# Access Compliance Report

## Public Rights-of-Way

### (Curb Ramps)

Intersection ID: 30109	Main Street: HARLAND_ST	Cross Street: WANDERING_CREEK_DR	Location: S
ADA ID: F112D50D9EC2	Ramp Type: PerpDiag	Initial Pass/Fail: Fail	Overall Compliance: No
Codes/Mitigation Info/Possible Solution		Field Measurements/Component Compliance	
Severity Score: 10

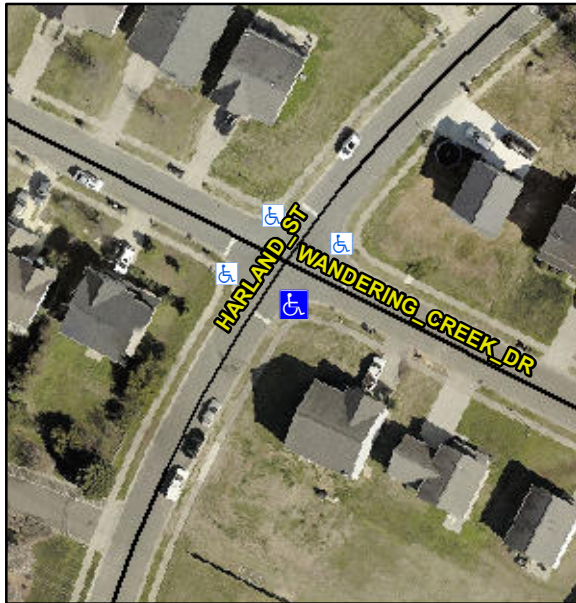
**Not Found, R304.5.1, R304.5.3**

Compliance	Description	Data	Compliance	Description	Data
N/A	Ramp Length (in)	60.0	Yes	Ramp Slope (%)	5.5
No	Ramp Width (in)	39.0	No	Ramp XSlope (%)	2.2
N/A	Flare Type LT	N/A	N/A	Flare Type RT	N/A
N/A	Flare Slope LT (%)	N/A	N/A	Flare Slope RT (%)	N/A
N/A	Flare Traversable LT?	N/A	N/A	Flare Traversable RT?	N/A
N/A	Landing Length (in)	N/A	N/A	DWS Provided?	N/A
N/A	Landing Width (in)	N/A	N/A	DWS Contrast?	N/A
N/A	Landing Slope (%)	N/A	N/A	DWS Length (in)	N/A
N/A	Landing X Slope (%)	N/A	N/A	DWS Full Width?	N/A
N/A	Landing Curb? (Y/N)	N/A	N/A	DWS Offset (in)	N/A
N/A	Shared Landing?	N/A			
N/A	Gutter Ponding?	N/A	N/A	Gutter Slope (%)	N/A
N/A	Gutter Lip Ht (in)	N/A	N/A	Gutter X Slope (%)	N/A
N/A	Painted X Walk1?	No	N/A	Painted X Walk2?	No
	X Walk 1 Direction	To NE		X Walk 2 Direction	To NW
N/A	X Walk 1 Width (in)	N/A	N/A	X Walk 2 Width (in)	N/A
	X Walk 1 Slope (%)	2.2		X Walk 2 Slope (%)	1.0
	X Walk 1 X Slope (%)	0.1		X Walk 2 X Slope (%)	4.2

**Remove & Replace Curb Ramp With Two New Directional Ramps or Equivalent.**
